SUBJECT: FOLLOWUP QUESTIONS REGARDING REACTOR VESSEL INTEGRITY DURING SEVERE
ACCIDENT CORE MELTS

Docket No. 52-003

INEL Comments and Questions about DOE/ID-10460

DOE/ID-10460 strategy for demonstrating AP600 In-Vessel Retention

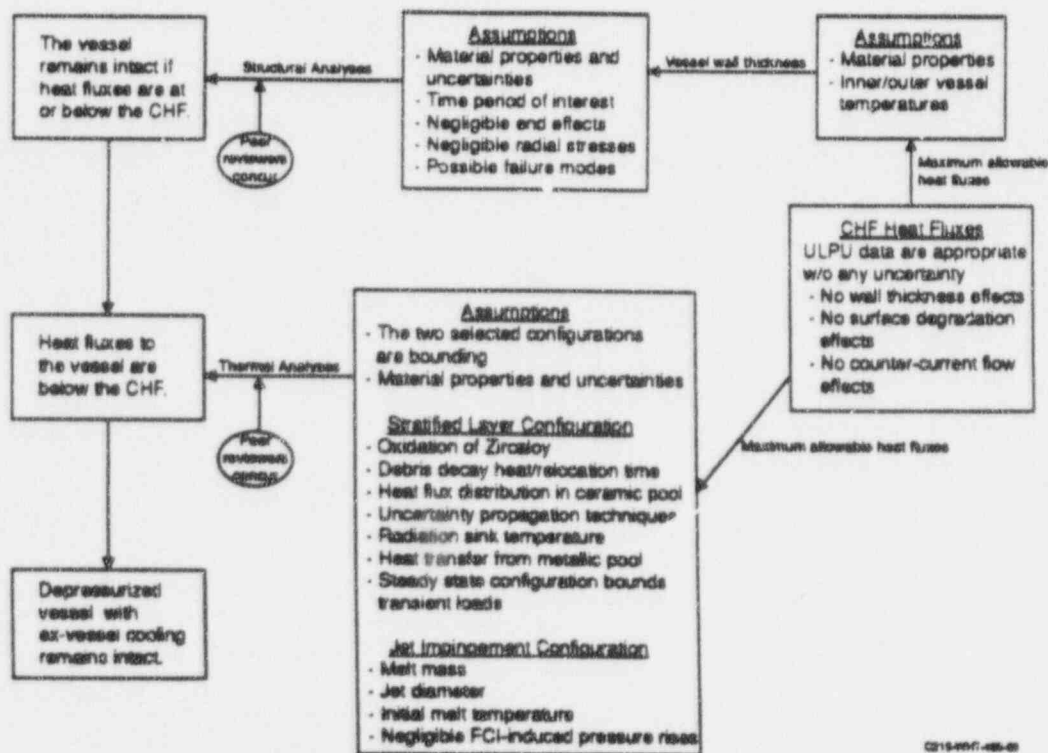
INEL's review indicates that Reference 1 applied the approach shown below to demonstrate vessel integrity for cases with complete RCS depressurization and ex-vessel cavity flooding. As indicated in this figure, the authors must prove two assertions in order to insure vessel integrity:

- For all heat fluxes at or below the CHF, the corresponding minimum vessel wall thicknesses are sufficient that the vessel remains intact.
- Heat fluxes to the lower head always remain below CHF.

As indicated in the figure below, various types of information (analyses, experiments, and assumptions) were used to support each assertion. Starting at the far right of this figure, the authors used CHF data from the ULPU tests to estimate minimum vessel thickness for the structural analyses and provide bounding heat fluxes for the thermal analyses. For the minimum vessel wall thicknesses, the authors performed structural calculations to demonstrate that the vessel remains intact if heat fluxes are at or below the CHF (Assertion 1). Thermal analyses are performed for two bounding configurations to determine maximum possible heat fluxes. These heat fluxes (and associated uncertainties) are shown to be below the CHF values (Assertion 2). Hence, the authors concluded that the vessel remained intact for cases with complete RCS depressurization and ex-vessel cooling. The authors relied on peer reviewer concurrence to validate the adequacy of the information supporting each assertion.

Figure 2. Comparison of correlations for predicting upward heat transfer.

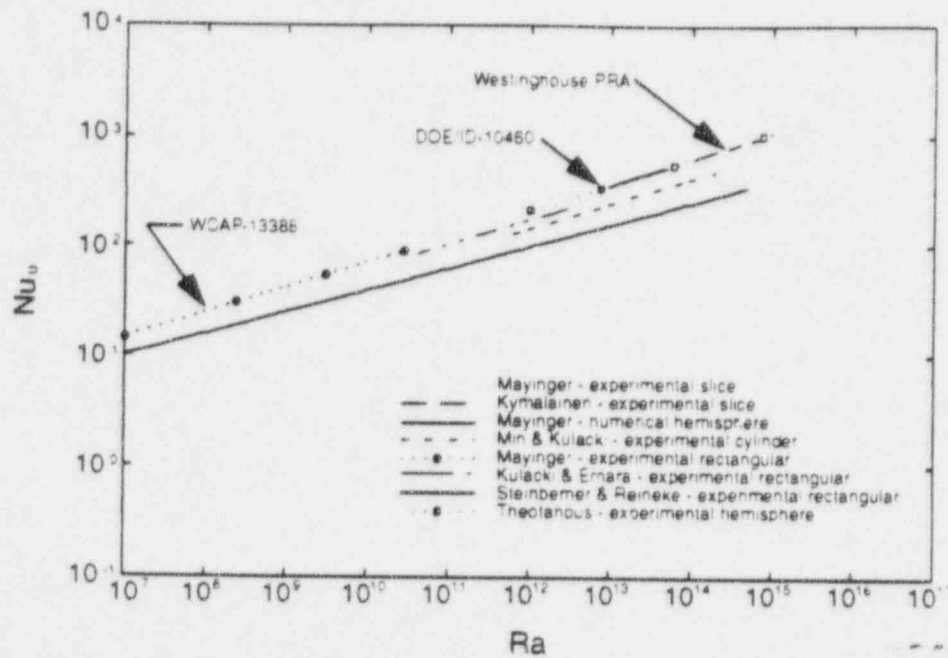
- 480.442 Figures 1 and 2 compare several natural convection heat transfer correlations developed from various experimental and analytical studies. In these figures, correlations are plotted over the range of Rayleigh numbers for which they were developed. As shown in these figures, there is considerable scatter between various correlations. Comparing the experimentally-developed, Kymalainen and Theofanous correlations, one can see that the ratio of upward to downward heat transfer is lower for the Theofanous data in the higher Rayleigh number range. Thus, an analyses assuming the Theofanous correlations (based on mini-ACOPO data) will predict less heat being transferred to the metal layer above the ceramic debris and reduced heat fluxes from the metal layer to the wall. This trend is demonstrated in Figure 7.15, which investigates a sensitivity in which the Mayinger correlation was substituted for the mini-ACOPO Theofanous correlation (the Mayinger correlation is lower than the Theofanous correlation for pool Rayleigh numbers of 10^{15}). Larger differences exist between the Theofanous and Kymalainen correlations than the Mayinger and Theofanous correlation for pool Rayleigh numbers at 10^{15} . In their response to Dr. Schmidt, the authors state that these differences are due to the shape of the lower boundary. However, this emphasis on geometry yields the author's data as the only data applicable to these tests. Furthermore, mini-ACOPO data do not agree with other hemispherical correlations at low Rayleigh numbers. Please perform a sensitivity study based on the Kymalainen data.

Figure 3. Comparison of area corrected localized Mayinger data.

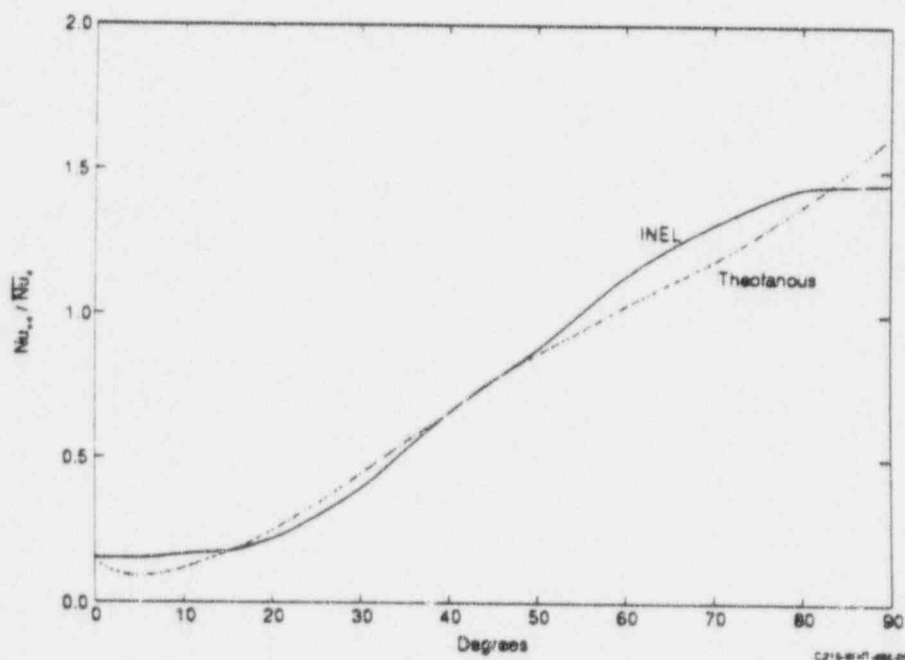
Please clarify how this equation was applied to obtain the Figure 5.8 Mayinger curve. Assuming the Mayinger (1985) curve is based on information from Mayinger (1975)^a and Jahn and Reineke (1974), INEL obtained the curve shown in Figure 3. Note that the peak local value (at 90 degrees) is lower than either the mini-ACOPO curve or the Mayinger (1985) curve shown in Figure 5.8. Please discuss the equations used to obtain the Figure 5.8 Mayinger (1985) curve and include the Kymalainen COPO local values in Figure 5.8.

Figure 4. Impact of boiling on heat transfer from a molten pool.

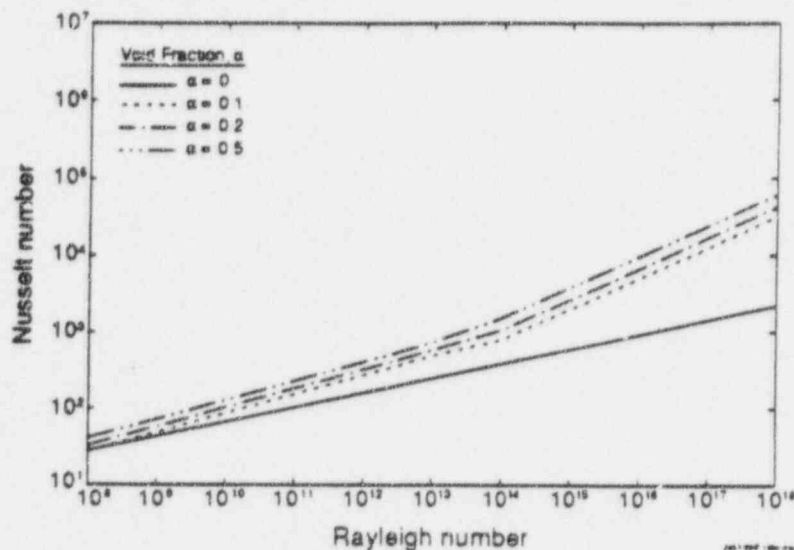
In Dr. Tuomisto's comments, he noted that the presence of materials with lower vaporization temperatures in the ceramic pool could increase heat transfer rates from the ceramic pool to the metal layer. In Appendix O, the authors responded that there is no mechanism for entrapping significant quantities of steel below superheated oxidic melt. However, there is a potential for superheated steel and control materials to be mixed within the molten pool. The presence of such lower vaporization temperature materials is supported by voids measured in examinations of debris from the TMI-2 vessel and the LOFT fuel damage tests (porosities of at least 20%). Using correlations based on experiments performed by Greene, et al.,³ INEL performed calculations to estimate the impact of vapor on heat transfer to the side walls.⁴ As shown in Figure 4, boiling significantly increases heat transfer for pool Rayleigh numbers of interest. Information in Reference 4 indicates that upward heat transfer experiences a similar increase because of vapor transport. Have calculations been performed to quantify the time required for these materials to vaporize from a ceramic pool? Please provide calculations assessing the impact of vapor transport effects on the margins to CHF.

Figure 5. Comparison of correlations for predicting upward heat transfer from the metal layer.

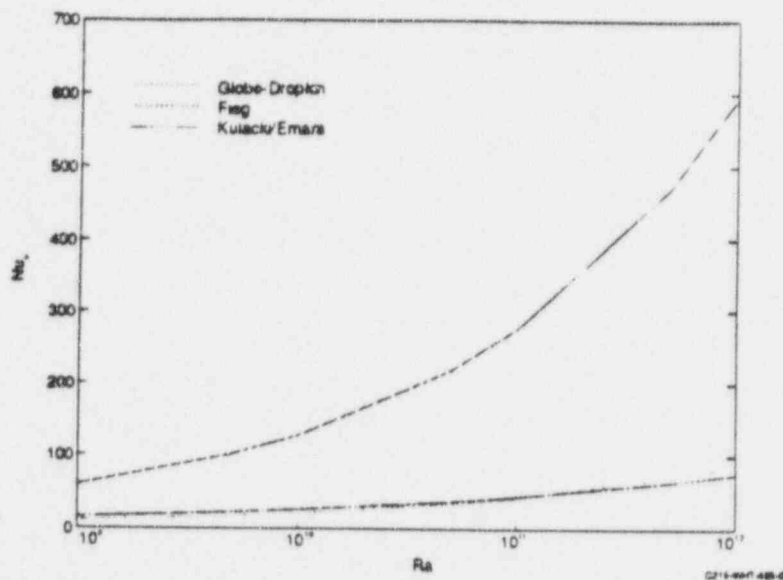
Correlations developed from Fieg and Kulacki, et al. for upward heat transfer are compared with the Globe-Dropkin correlation in Figure 5. As shown in this figure, the Globe-Dropkin correlation applied in Reference 1 predicts higher upward heat losses from the metal layer. Assess the impact on results if the Fieg and Kulacki data were used instead of the Globe-Dropkin correlation.

Figure 6. Possible CHF-limited vessel wall thicknesses (Upper bound assumptions correspond to maximum vessel melting temperature and reduced CHF values; Lower bound assumptions correspond to minimum vessel melting temperatures and maximum CHF values).

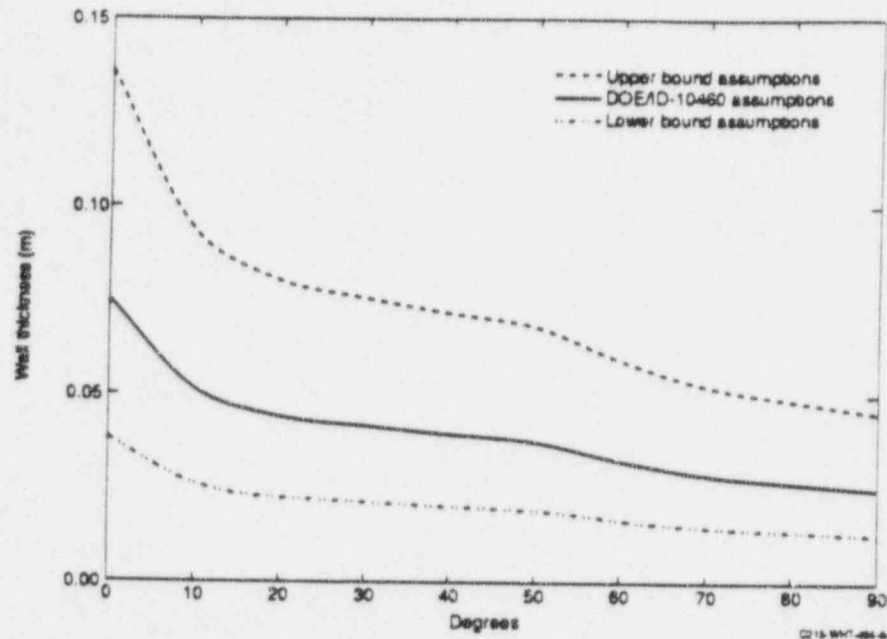
For example, it appears that Figure 4.1 was obtained by using the best estimate values for critical heat flux (Figure 3.3), vessel wall thermal conductivity (32.0 W/K-m per Table 7.1), and iron-zirconium liquidus temperature (Figure 6.1). If one considers the uncertainties in the vessel thermal conductivity ($\pm 10\%$ according to Appendix L) and the iron-zirconium liquidus temperature (variations in the mole fraction of zirconium may lead to liquidus temperatures between 1201 and 1948 K), the CHF-limited wall thickness could be as small as 1.5 cm (compared to the 2.5 cm shown at 90 degrees in Figure 4.1). If one were to consider the uncertainties estimated by others for similar experiments ($\pm 20\%$),⁵ the CHF-limited wall thickness would be reduced even further as shown in Figure 6. As discussed in the structural analyses comments, this thickness (and other uncertainties related to the structural analyses presented in Section 4) reduces the robustness of Section 4 conclusions, and the finite element calculations should be revised using an appropriate vessel wall thickness

dreds of degrees. However, Section 4 only indicates that one temperature was considered. As discussed above, if the range of possible temperatures were considered along with other uncertainties in predicting the wall thickness, the range of wall thicknesses shown in Figure 6 are possible. Please revise this analysis assuming an appropriate minimum wall thickness.

Figure 7. Possible endstates that may be more challenging than the Reference 1 endstate.

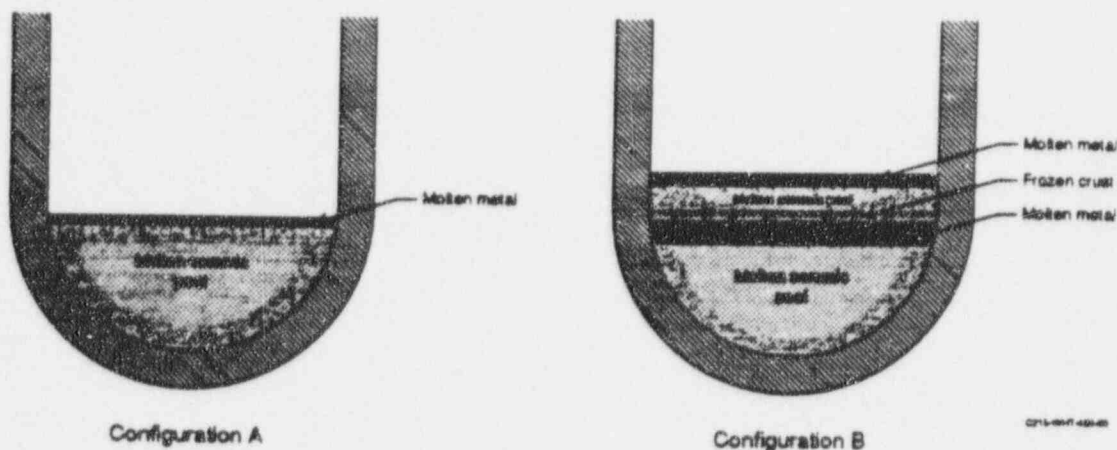
- 480.455 As noted by Levy and a number of the reviewers, the assumed end state condition shown in Figure 2.2 is not necessarily the bounding or even most plausible configuration for the stratification of frozen and molten material. Figure 7 illustrates several possible asymmetric, idealized configurations that may be more challenging than the one assumed in Reference 1.

- Configuration A corresponds to results from SCDAP/RELAP5 calculations for a similar scenario. (This calculation is not yet complete in that a further assessment of lower head heat transfer and the potential for additional relocation of steel is still to be completed). The configuration is characterized by a large oxidic pool (~85% of the core inventory) with a small metallic component (~5600 kg of unoxidized Zr and ~3400 kg of stainless steel). This configuration developed primarily as a result of localized relocations through the reflector sidewall. The stainless steel component accumulated from the melting of gray rods and the addition of lower plenum structures that melted as a result of being submerged by the debris. Calculations suggest that this configuration could persist for a period of time necessary to completely boil water in the lower head and then melt portions of the lower core plate. During this period, the metallic layer of ~10 cm would remain well below the threshold of 15 cm, which was given as the thickness necessary to insure vessel integrity under 'focused' heat loads. Furthermore, asymmetries *could* be expected in the core region as a result of the break location and the conditions that could develop in the vicinity of other major vessel penetrations (e.g., accumulator flow lines, core makeup line). These asymmetries that could significantly reduce steel melting and, ultimately, the thickness of the 'focusing' layer. In the main results, please assess the impact of a thin-metallic layer on lower head integrity, as a result of potential relocation scenarios and as a result of acknowledging asymmetries in core melt progression.

In Configuration B, a second pour would relocate onto the core plate forming a crust above the core plate. Any subsequent pours result in a second molten pool with a thin metal layer above it. As discussed above, multiple pours are possible because there are non-axisymmetric heat transfer boundaries. The core plate would be heated from below by the molten pool and above by the overlying crust. Metal in the core plate would become molten and eventually superheated, possibly resulting in a more severe heat load to the vessel than that postulated in the report. Hence, the idealized configuration shown in Figure 2.2 is only one of many plausible configurations. As discussed in Appendix O, factors such as the "random nature of boiling crisis (as found in ULPU), natural asymmetries in the thermal loading," etc. will make it highly unlikely that the actual endstate in the lower head is axisymmetric. Hence, there are a number of additional scenarios that could have been considered that may be more plausible than the configuration presented in Figure 2.2. As Dr. Levy noted, if the molten stainless steel becomes trapped below a crust of ceramic material, the molten stainless steel must either continue to heatup above the melting point of the ceramic crust or mechanically break through the crust to migrate to the top of the ceramic layers. In the event that molten steel becomes trapped below a crust of ceramic material, please assess the thermal loads on the vessel and the margin to vessel failure in the steel region.
